I appreciate the efforts conducted by the authors since they tried to answer all my points. While I'm not completely convinced by it, I recommend it for publication after a few minors.

Figure 1 The geographical location of the Luanhe River basin

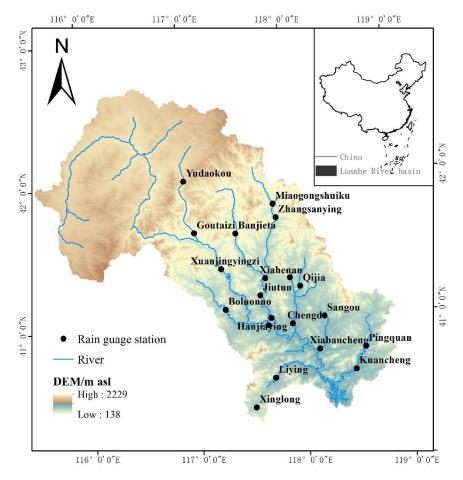
2. Figure 1 The names of the rain gauge stations are not visible; I suggest the authors use different font colours; moreover, in the legend DEM in m asl.

**Response**: Thanks for the expert opinion, in order to make the name of the rainfall station clear, Figure 1 has been readjusted. Moreover, in the legend DEM in m asl.
